MEMORANDUM

Reference:	DA22/0318
To:	Sydney Western City Planning Panel
From:	Donna Clarke – Landmark Planning, Consultant Planner on behalf of Penrith City Council
Date:	6 March 2024
Owner:	Penrith City Council
Applicant:	GLN Planning
Subject:	PPSSWC-243 - DA22/0318 - Torrens Title Subdivision into 37 Industrial Lots, 1 Stormwater Management Infrastructure Lot & Public Roads including Earthworks, Civil Engineering Works, Tree Removal & Public Domain Landscaping - 158 - 164 Old Bathurst Road, Emu Plains

Figure 1: Extract mound retention plan prepared by Acor, dated 1 March 2024

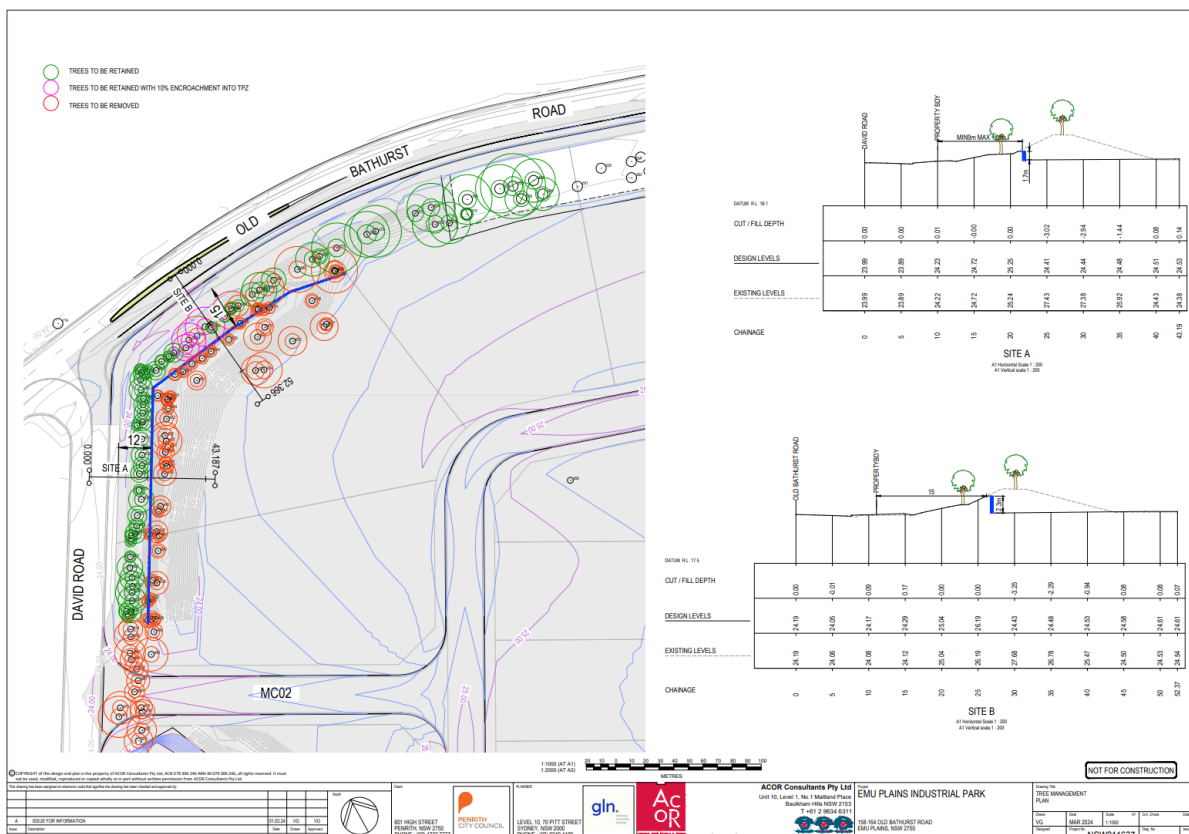
The Applicant's letter indicated partial mound retention and indicated *"The portion of the mound being retained will vary in height between approximately 1.7m and 2.3m above the adjoining road level"*.

Figure 1 indicates in both plan and section form the extent of the batter into the proposed lots, as well as the location of the existing trees. The plan and section indicates tree retention (shown green and pink on the plan) for the part closest to the two roads and the second row of trees on the mounding and other trees being removed (shown red on the plan), the whole mound being removed, and a retaining wall (shown blue on the plan) proposed.

In my opinion, the plan does not include any mound retention, as can be seen clearly in the Sections on the plan. The area suggested to be part of the mound being retained by the Applicant is the lower battering of the mound on one side only and does not have the height which is characteristic of the existing mound. The height of 1.7m and 2.3m above the adjoining road level indicated by the Applicant relates to the highest point at the top of the retaining wall and is not reflective of the landform of the majority of this area. The plans do not indicate the height of the top of the existing mound, but from a review of Site A Section, the top is estimated to be 5.1m, which is a removal of 3.4m of height.

- a) This sketch achieves only limited canopy tree retention and a row of trees remains for the lower part of the frontage close to the street (i.e. no trees are retained on an elevated mound). The Sections provides an illustrative depiction of the extent of the mounding and existing trees which are being removed (i.e. existing mound shown dotted and existing trees on top), which has not previously been provided. It is clear on the plan that a substantial area is being removed with no part of the mound remaining, therefore no elevated natural screening or shading remains with only a row of trees at ground level.

- b) The amount of shade extending into the site onto the proposed lots provided by the existing trees on top of the mound will not be able to be achieved by the plan, either initially whilst trees grow, or in the future due to the sizable reduction in ground levels due to mound removal.

As detailed in the Assessment Report and the recommended Deferred Commencement Consent, there was an expectation that the trees and mounding below could remain, however, the wide batter associated with the mound which extends into the rear of the proposed industrial lots could be reduced by way of engineered retaining at a sufficient distance from the trees to ensure their long term survival. This would ensure the height of the existing mound is retained, as well as the trees on top.

Figure 2: Recommended Retaining Wall location on Sections from mound retention plan. Blue is as proposed by the Applicant & Red is approximate as envisaged deferred commencement condition (subject to further arboricultural assessment and engineering detail)

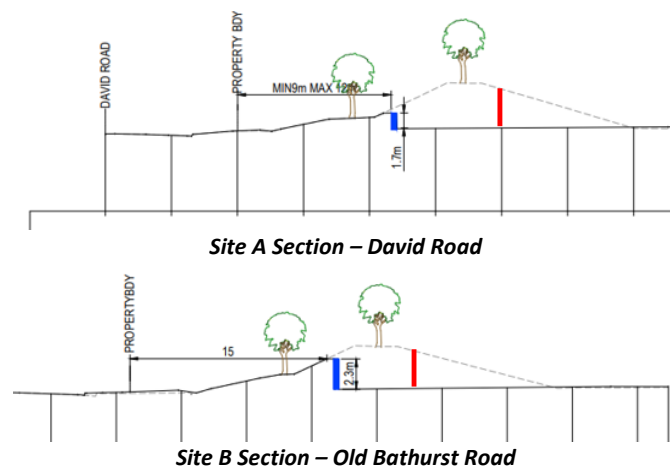
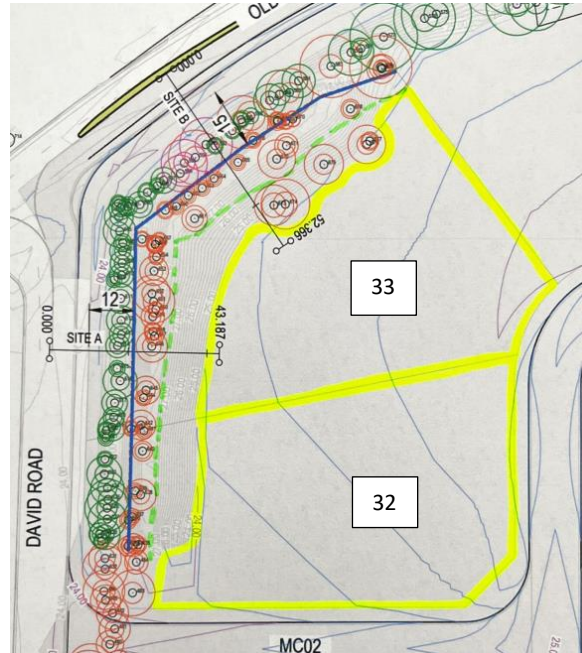
- d) On the Applicant's mound retention plan, the proposed retaining wall is shown blue. This is considerably closer to David Road and Old Bathurst Rd than anticipated. In my planning assessment of the application, I had envisaged that the retaining wall would have been approximately where I have indicated red on the extract below in Figure 2 and allowed for the retention of the two main rows of trees (and mound below). This red line provides for more developable area than the mound being retained in full but still achieves the necessary mound and tree retention to achieve the legislative controls regarding urban heat and landscape and scenic values.

- e) Both the blue and red lines shown on the above plan in Figure 2 require further investigation to ensure that the retaining wall location is acceptable with respect to the trees remaining and their long term viability and health. The proposed blue line location assumes that tree roots do not extend past the calculated tree protection zone but as they are young, they may extend further and the proposed location of the retaining wall does not provide sufficient space for the continued growth of the tree. Following the Panel meeting, a sketch from Council's Tree Management Officer was provided to the Applicant which indicated the retaining wall back further to provide room for future growth (similar to the red line location). This sketch appears to have been ignored in preparation of the plan by the Applicant.

- f) The retaining wall is red is a more acceptable location, however this would be site dependent and require a thorough assessment which was expected to occur prior to satisfaction of the Deferred Commencement condition. In locating the retaining wall, there needs to be consideration as whether there is an intrusion into any of the TPZ's but also there needs to be sufficient room for the continued growth of the trees. Further, construction techniques for the retaining wall is unknown and likely be detrimental to the trees (e.g. drainage behind the retaining wall), particularly in regard to the time root systems may be exposed to the elements. As such, it is expected that the retaining wall will need to be relocated further into the proposed lots once the construction techniques are identified. The proposed Deferred Commencement condition requires the Arborist and Engineer to review together to determine the location of any retaining.

- h) The proposed retaining wall is up to 2.3m high and should provide for terracing to reduce the overall sheer height and landscaped.
- i) The Applicant has indicated that *“The extent to which the mound is being retained (as proposed in the attached plan) on the Site exceeds the minimum landscaped setback requirements as outlined within the Section D4 of the Penrith City Council Development Control Plan 2014 of 15m for Old Bathurst Road and 9m for David Road”*. I have discussed this within the assessment report and reconfirm that the DCP numerical setback is not the only consideration and the DCP objectives of that control extend to qualitative outcomes that necessitate a reasonable level of tree retention. It is not sufficient to only apply a setback line to future built form to then inform retention as any proposal warrants a setback commensurate with whatever is needed to ensure the protection and retention of the trees or at least sufficient trees to screen the development and comply with urban heat and scenic quality considerations in the LEP and DCP. Setback controls cannot be considered in isolation and must also have regard to other controls which require developments to be designed to ensure that existing mature trees can be retained.
